## PUBLIC NOTICE

City of Lockhart  
Planning and Zoning Commission  
7:00 PM, Wednesday, August 10, 2022  
Municipal Building – Glosserman Room  
308 W. San Antonio St.

STAFF CONTACT: Kevin Waller, Senior Planner *KW*  
REPORT DATE: August 5, 2022  
PLANNING & ZONING COMMISSION DATE: August 10, 2022  
STAFF RECOMMENDATION: *Approval*  
SUGGESTED CONDITIONS: None

STAFF CONTACT: Kevin Waller, Senior Planner *KW* CASE NUMBER: FP-22-05  
REPORT DATE: August 5, 2022

FINAL PLAT OF LOCKHART FARMS ADDITION PHASE 2 36.18 ACRES, CORNELIUS CRENSHAW SURVEY, ABSTRACT 68 LOCKHART, CALDWELL COUNTY, TEXAS

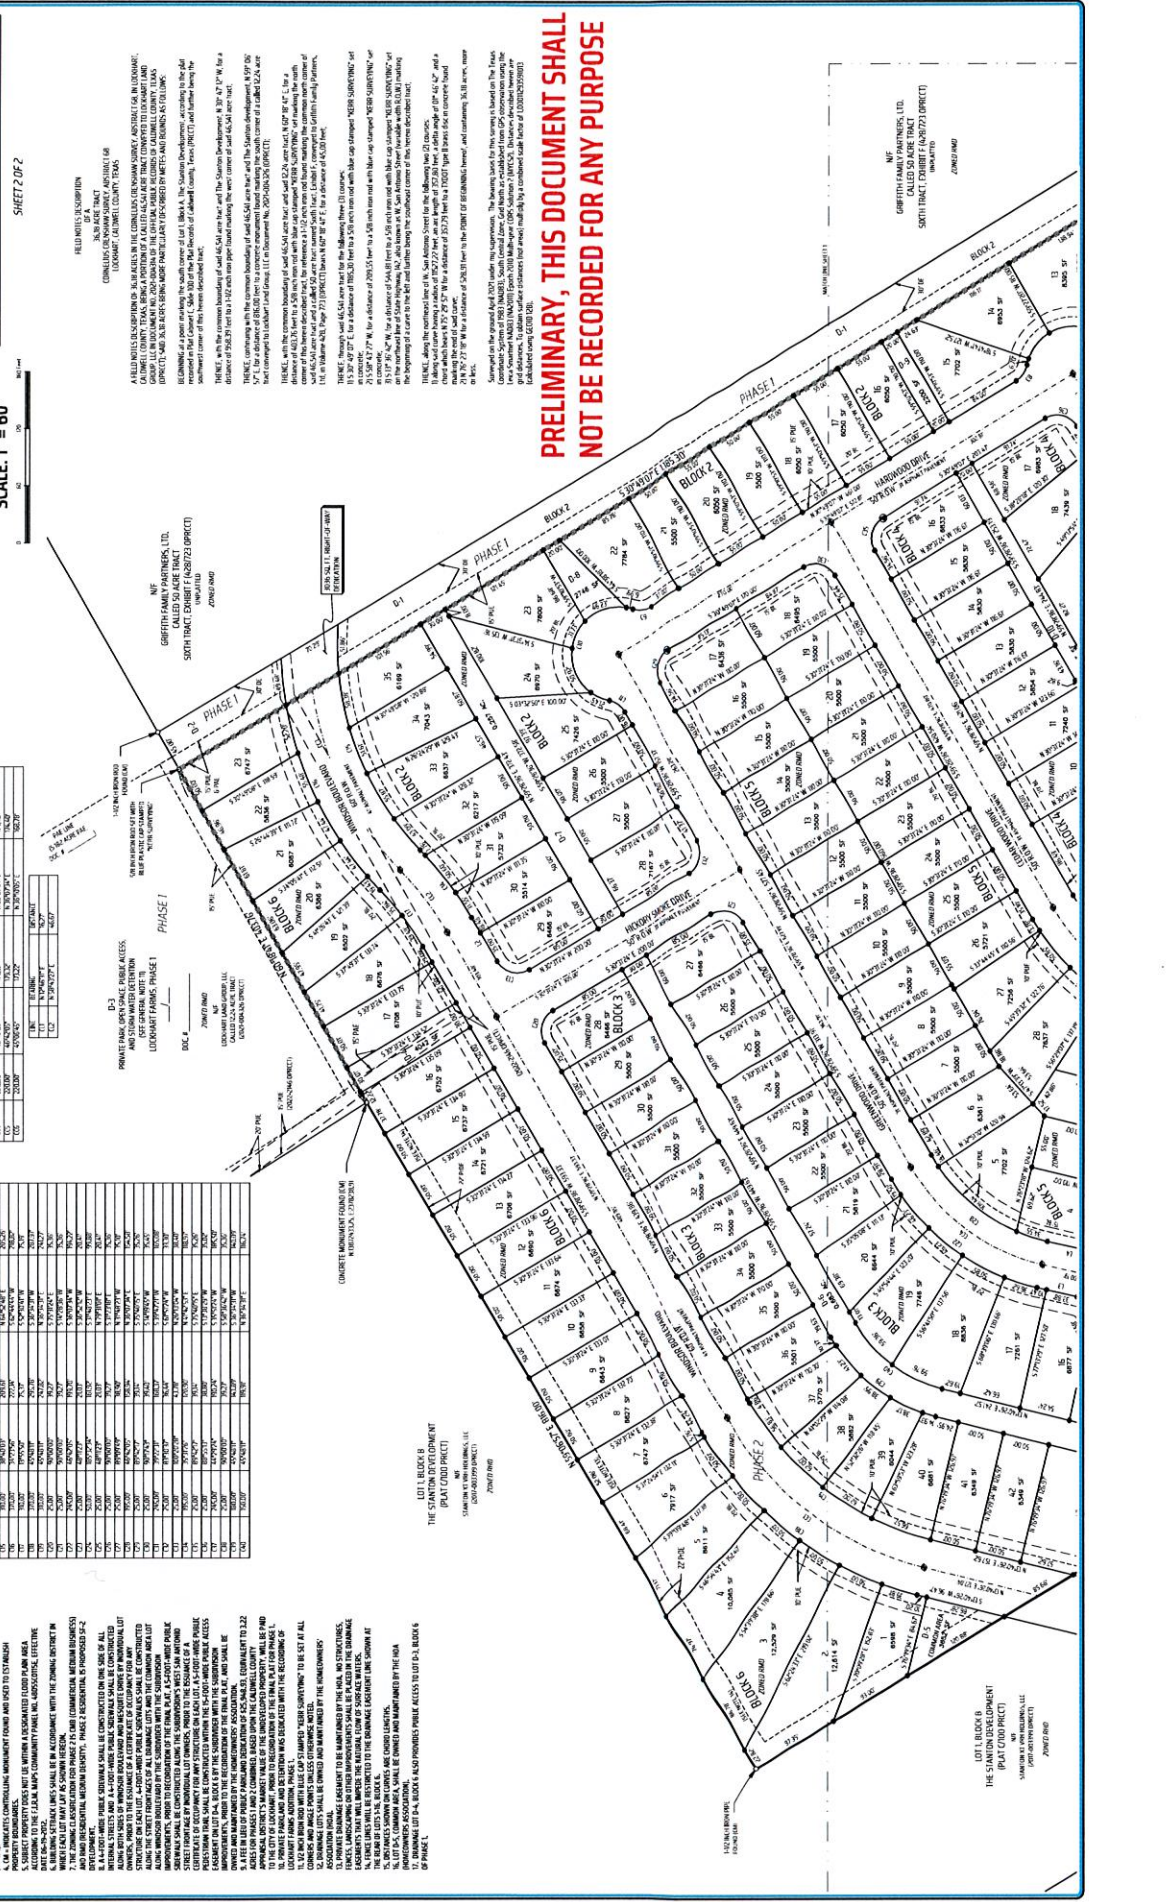
PROPOSED DEVELOPMENT: The Lockhart Farms Addition Preliminary Plat and Subdivision Development Plan (PP-21-06) was conditionally approved by the Commission on October 27, 2021, and the Final Plat of Phase 1 was conditionally approved on November 17, 2021. The current proposal is for approval of the Final Plat of Phase 2. With the proposed Hansford Subdivision and the multifamily lot of Lockhart Farms Phase 1 to the east, and the Stanton Development to the west, the proposed Phase 2 includes 147 single-family-residential lots, two commercial lots, 6 drainage lots, and one common area lot. Sidewalks will be provided on one side of the internal streets, along both sides of the Windsor Boulevard extension and Mesquite Drive, and along the property's West San Antonio Street frontage. A five-foot-wide public pedestrian trail, although primarily located within the physical boundaries of the first phase, will serve the single-family development in Phase 2 and be constructed with that phase. The trail will also connect to Windsor Boulevard and tie into the sidewalk that will connect with the Hansford Subdivision. The subdivision will be served by a regional detention pond located within Phase 1, north of Phase 2, that is proposed to also serve the Hansford development and a future phase of the Stanton Development. Parkland will be provided within the regional detention area. Although the parkland meets the minimum-required 8 percent of total land area for both phases of the subdivision, it does not abut a public street and will not provide parking, and is therefore proposed to be private with ownership and maintenance by a Homeowners' Association. As such, a fee in lieu of public parkland dedication is proposed to be paid, prior to recordation of the final plat of Phase 1, as specified in General Note 9. The subdivider has proposed to construct a playscape in the private park area, however, no note appears on the plat.

**COMPLIANCE WITH STANDARDS:** The plat complies with all applicable subdivision standards, including construction of new streets where required, the provision of public sidewalks, utilities, stormwater drainage, and the payment of a fee in lieu of public parkland. As noted in the attached letter dated June 22, 2022, the City Engineer has approved the engineering plans.

Approval of the construction plans is contingent upon providing approval from TxDOT for driveways and culverts within TxDOT ROW once received. Any proposed improvements related to the TxDOT ROW to include driveway, culverts and stormwater conveyance shall not commence until TxDOT approval has been received.

# RUCKER ACRES ADDITION

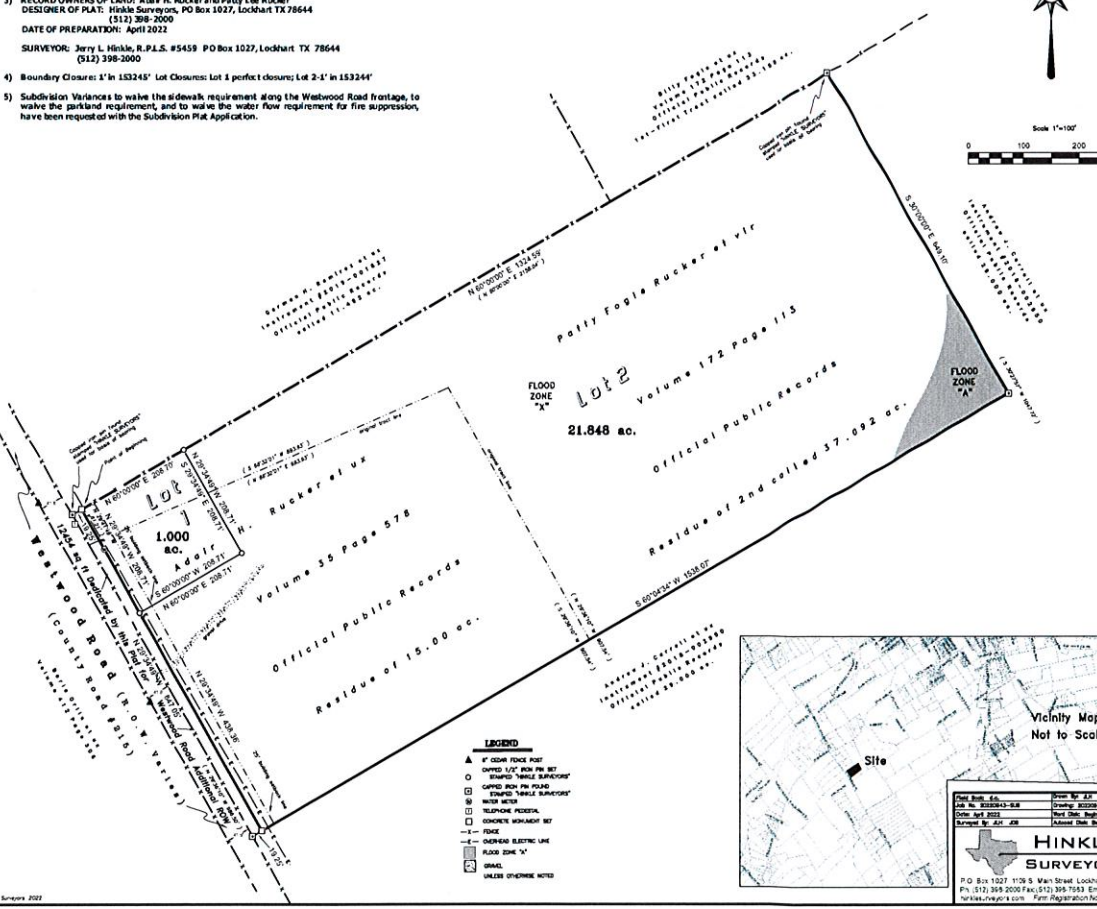
PROPOSED DEVELOPMENT: The property is located within the Lockhart one-mile Extraterritorial Jurisdiction (ETJ), where the City regulates subdivision activity if one or more resulting parcels are ten acres or less in size. The applicant proposes to divide the property into two parcels, one of which will be less than 10 acres. The proposed land conveyance is not eligible for Caldwell County’s Family Land Grant procedure, which is typically where a Subdivision Platting Variance is also requested from the City requirements, since the newly created parcel will not be sold or gifted to a family member of the owner. The owner proposes to create a one-acre lot from a 22.848-acre parcel, as shown on the subdivision plat, with a single-family residence to be constructed on the new, one-acre parcel (Lot 1). A single-family home and several outbuildings already exist on the proposed 21.848-acre parcel (Lot 2). The FEMA-mapped 100-year floodplain (A Zone, no elevation study) traverses a small portion of the east corner of Lot 2, which is a considerable distance away from the existing development on that lot. The applicant also proposes to dedicate additional right-of-way along the Westwood Road frontage, since the street has a substandard right-of-way width for arterial streets, as shown on the plat drawing.

CONCURRENT VARIANCES REQUESTED: Three Subdivision Variances are requested with this application, as follows: (1) To the requirement for construction of a public sidewalk along the abutting street (Westwood Road) (Section 52-77(b) of the Subdivision Regulations); (2) to the requirement to dedicate or pay a fee in lieu of parkland dedication for a residential subdivision (Sections 52-112(a)(2) and 52-113(a)(2)); and (3) to the requirement that public improvements be designed and constructed in accordance with the City's construction standards (specifically the minimum water flow standard for fire hydrants) (Section 52-141(a)).

In the applicant's attached written statement addressing the four variance criteria, it is explained that: (1) it is not feasible to construct a sidewalk along a County-maintained road outside the City limits, where no other sidewalks are present; (2) a large, existing pond on the property could assist with fire suppression in the absence of fire hydrant water flow from the existing four-inch Aqua water line; and (3) residents of the two proposed lots are not anticipated to travel into town to utilize City parks. While Staff supports the Variance requests to the sidewalk and fire flow requirements, we believe that the subdivision residents do have the option of utilizing City park facilities, and as such, the applicant should at least be subject to payment of the fee in lieu of parkland dedication.

STAFF RECOMMENDATION: ***Approval of both the Plat and two requested Subdivision Variances to the sidewalk and water flow for fire hydrant requirements; Denial of the requested Variance to waive the parkland dedication or fee in-lieu of dedication requirement.***
